**CITY OF JOHANNESBURG IMPACT ASSESSMENT AND COMPLIANCE MONITORING**

**ADDENDUM 1 | RESPONSE TO CITY OF JOHANNESBURG IMPACT ASSESSMENT AND COMPLIANCE MONITORING COMMENTS DATED 12 OCTOBER 2020**

Steyn City Properties (Pty) Ltd. plans to develop Riverside View Ext 84 on portions 124 and 185 of the farm Diepsloot 388 JR. The proposed zoning of the development will be *Special for: Place of Instructions, Residential buildings and Offices, including ancillary uses such as restaurants and shops* and aims to provide a school, offices and residential buildings. Private Open space will also be incorporated into the development which form parts of the Steyn City Parkland Residence which has been designed to be a modern, mixed land use and mixed income development.

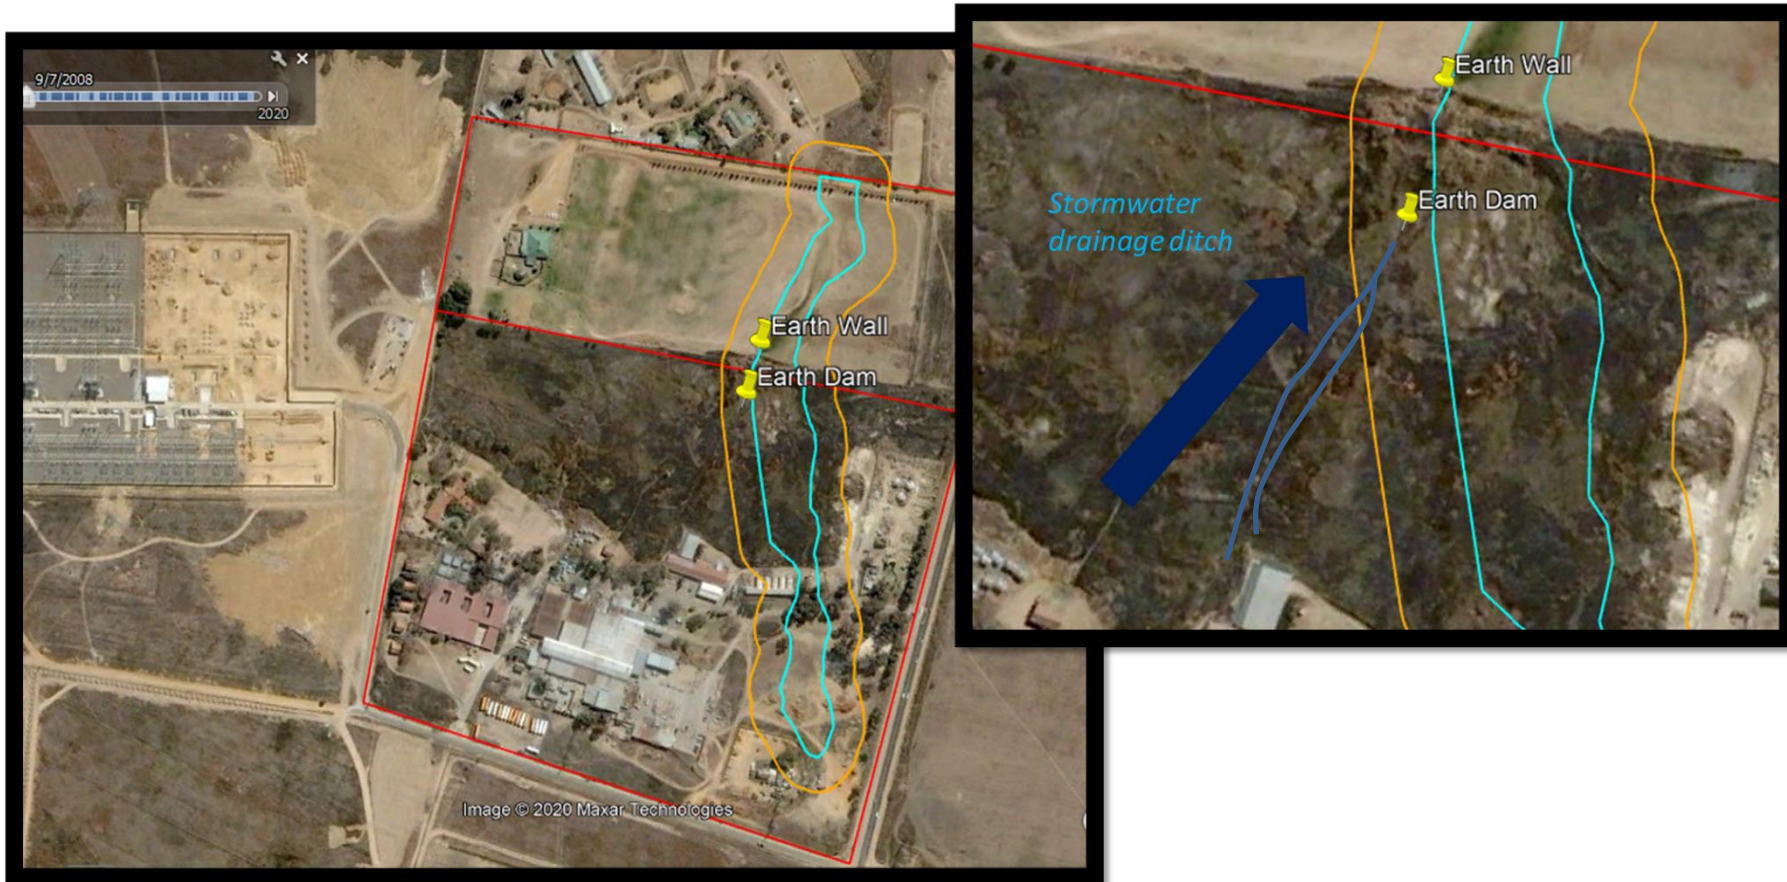
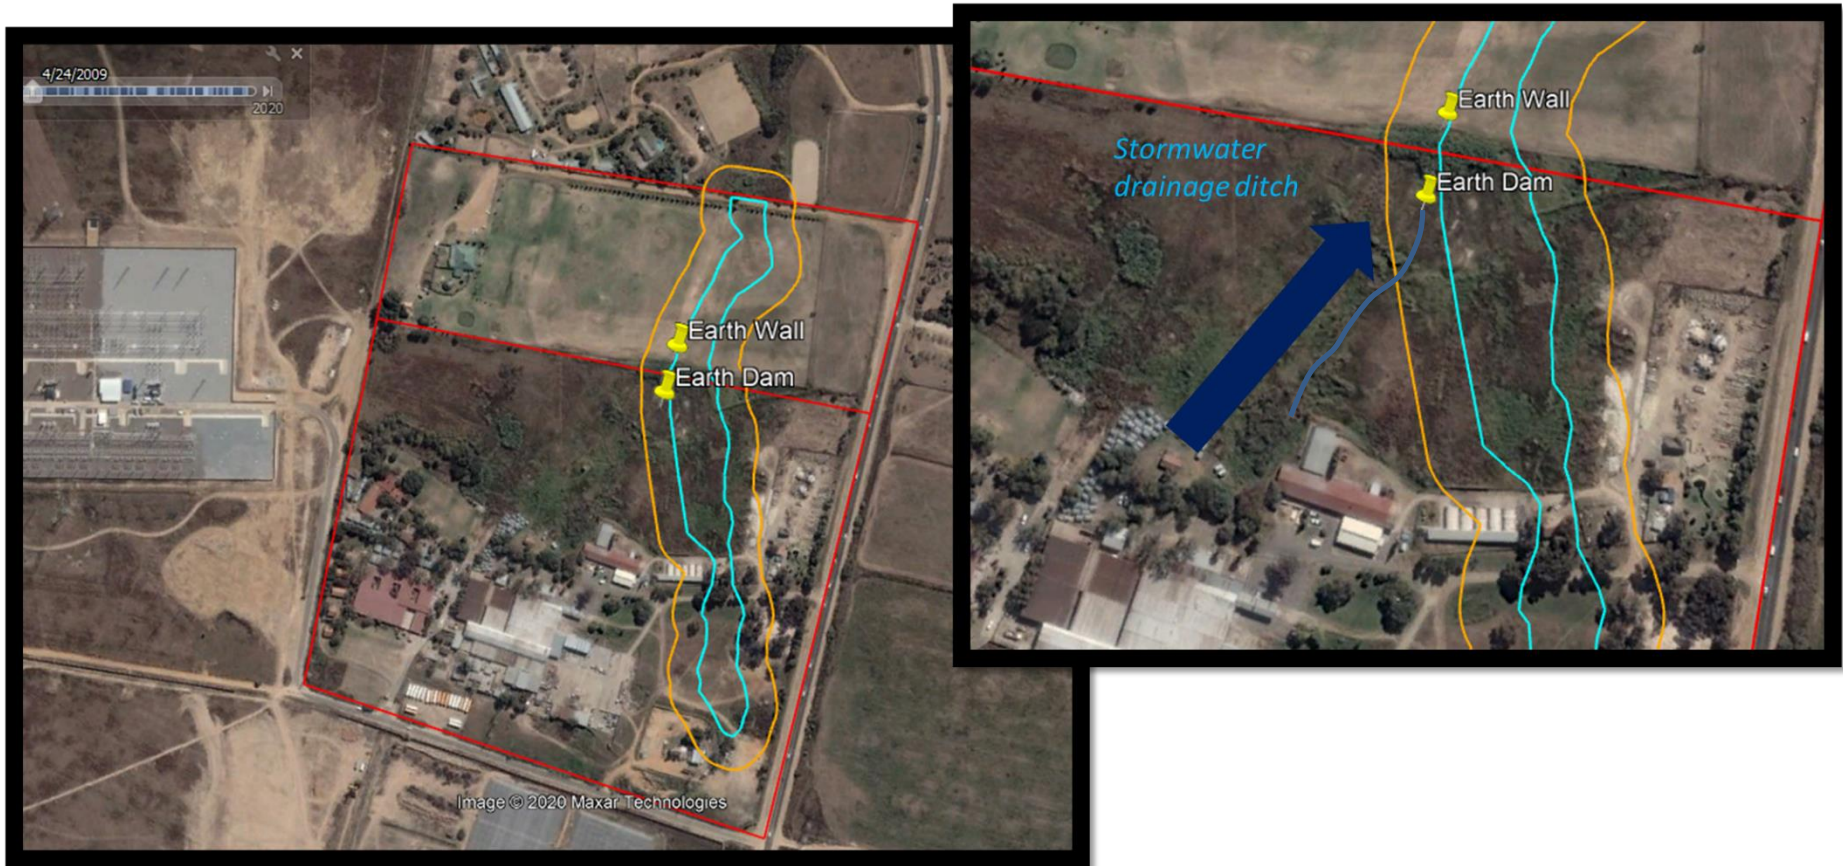
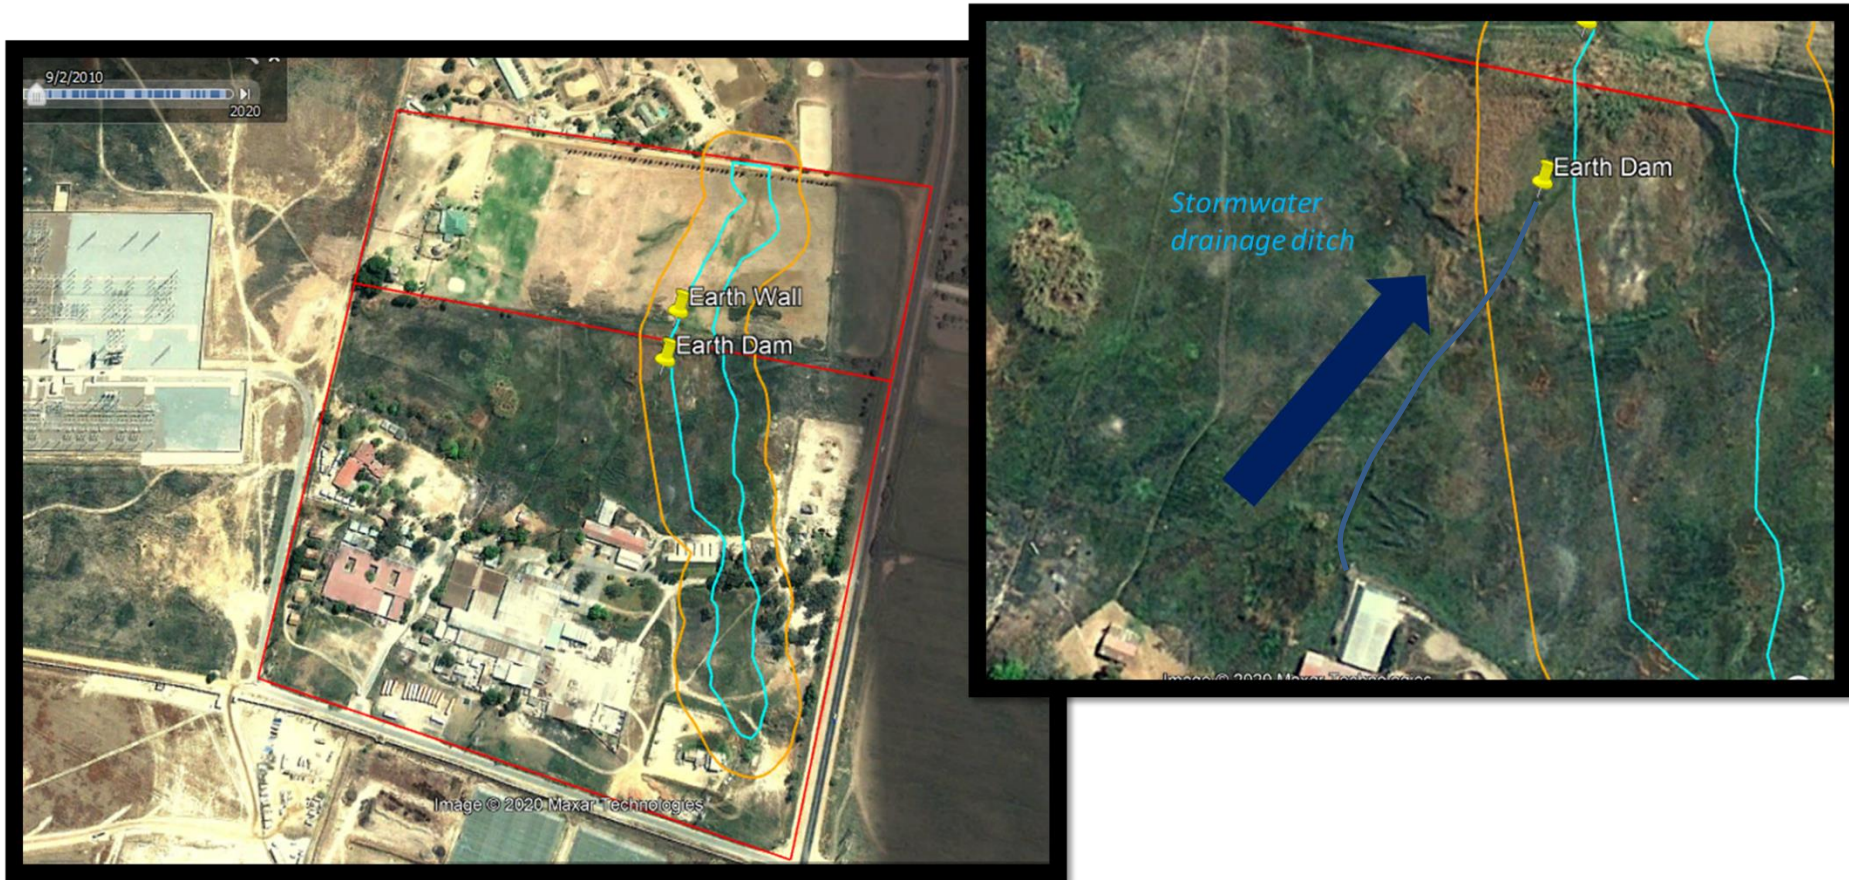
- *"Biodiversity Baseline and Impact Assessment:*
  - *In terms of the report, wet areas were also identified within the recovering grassland habitat. It is however presumed that the source of the water in these areas is from an artificial source. An investigation must be done in the final EIR on this unnamed artificial source. The findings of the Geotechnical report must be taken into consideration and the investigation must include the relationship between the seepage areas and the high biodiversity area.*

- *Wetland Assessment:*
  - *The wetland study appears to disregard the large seepage wetlands associated with the main valley bottom wetland and dismisses these. Given that the details of where verification was undertaken and the results of augur points are not provided, it is not clear how the conclusions that these seepage areas are artificially driven are arrived at.*

- *Further, the geotechnical report by the engineering geologist confirms the presence of seasonal perched groundwater tables and/or saturated soil profiles, not confined to the riparian zone only. Figure 9-11 indicates extensive areas designated as Zone III which are noted to be wet and marshy. This would be consistent with the National Wetlands Map 5 (Van Deventer et al 2019) and the City's own indicative wetland layers. The historic vegetation maps appear to show these areas in existence. Furthermore, extensive seep wetlands associated with valley bottom wetlands is a common feature of the Halfway House Granites.*

- *The statement under section 9.1.1.3.2. that wet areas associated with the grasslands can be presumed to be water from an artificial source' cannot be accepted at face value and without a thorough analysis. It is even possible that there may be changes to the hydrology as a result of the disruption of flow paths which has already taken place to parts of the wetland as a result of existing development such as roads etc. which appear to have encroached into, and destroyed parts of the wetland especially in the north western section."*

- The site was developed as a golf driving range with driving tees and sand bunkers as well as a restaurant and club house. Most of the site is cut lawn.
- Portion 185 of the Farm Diepsloot 388 JR
  - The site was developed as a school, panel beating shop, car spray paint business and dimension stone seller. As part of this the southern sections of the wetland were partly developed.
  - In this regard it should be noted that just to the centre of Portion 185, stormwater was released from the school and buildings which affected the vegetation of the site.

Please refer to **Figure 2, 3 and 4** below.

What is of particular importance to note is that the geotechnical reports by J Louis Van Rooy were undertaken during this period and thus were influenced by the status of the site at the time of the studies:
